SUBJECT: FCC Class II Permissive change for FCC ID: U7I-BP3KV1-5W

We, the undersigned, would like to request a Class II Permissive Change for the FCC ID: U7I-BP3KV1-5W, which was originally granted on 02/14/2022.

The location of the change

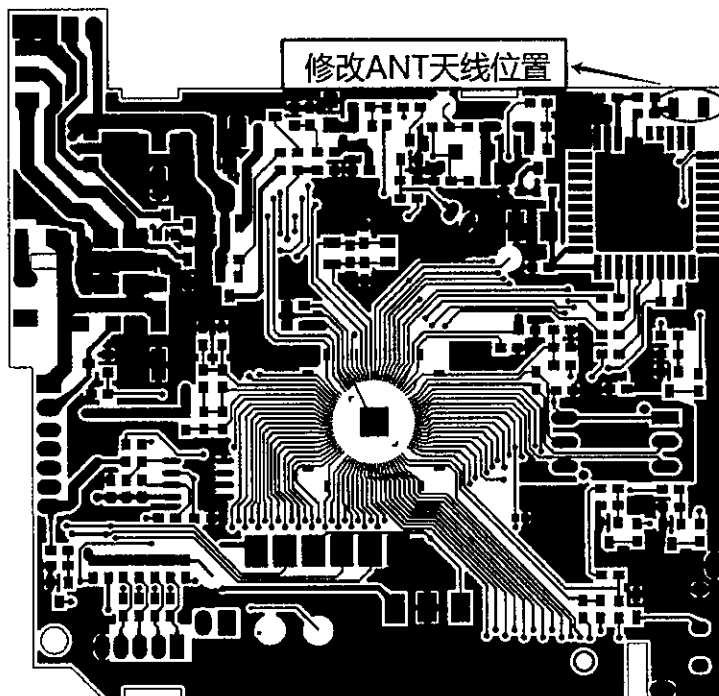
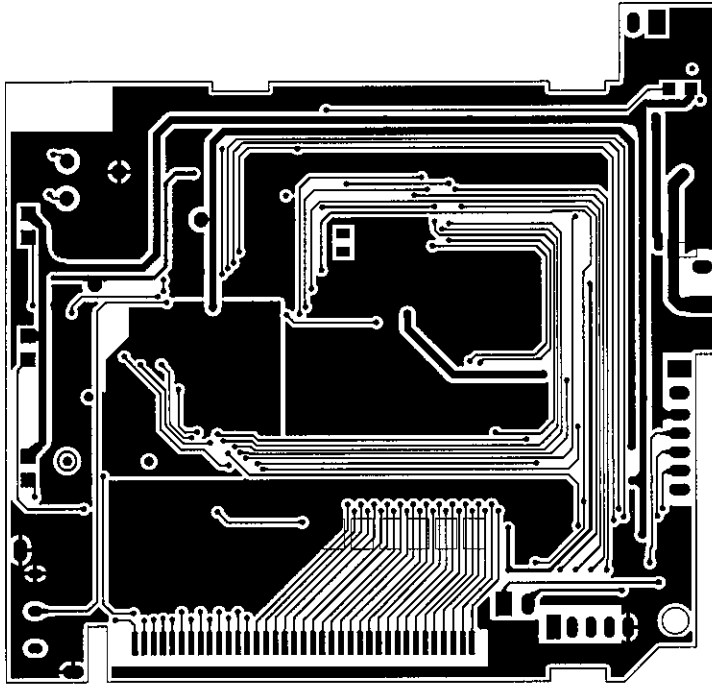
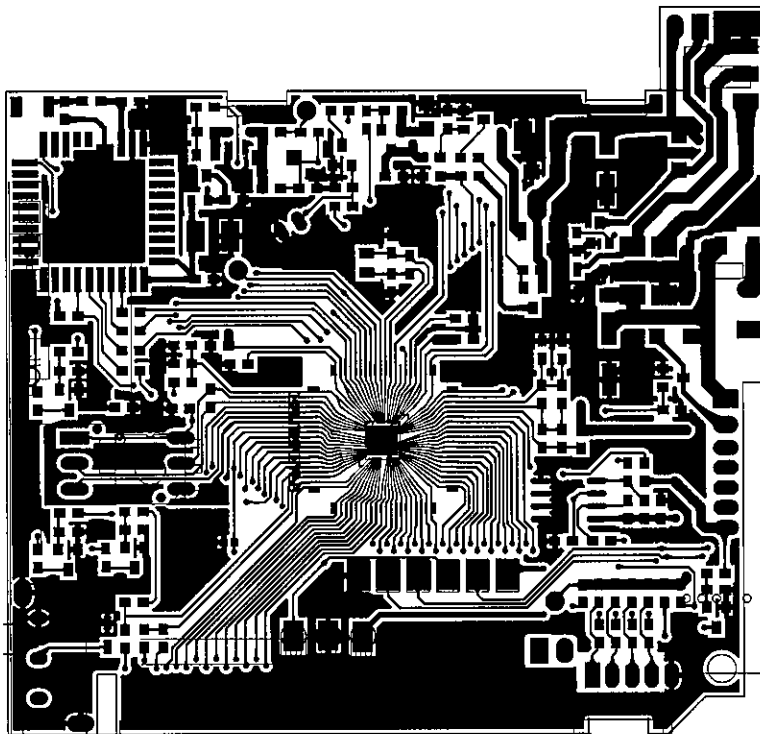
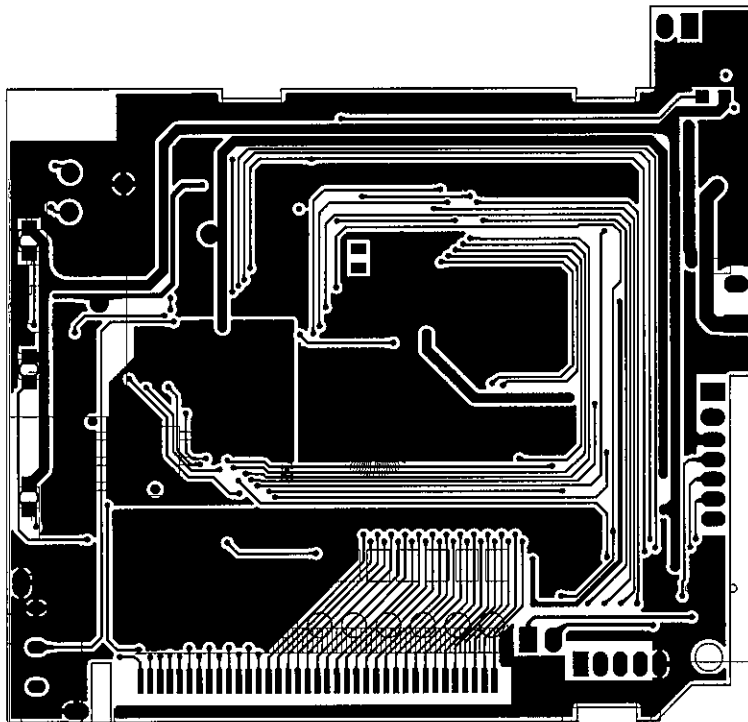
- ① Canceled the USB function: PCB was not changed.
- ② The position and model of the antenna in the upper right corner are changed:

Antenna parameter:

Before: BTCAKC321609002G4Y SMD3.2x1.6x1.2mm (Xiamen Holder Electronics Co.,Ltd)

New: ANT3216R24003KL0 SMD 3.2x1.6x0.6mm (Shenzhen P.D.T Electronics Co.,Ltd)
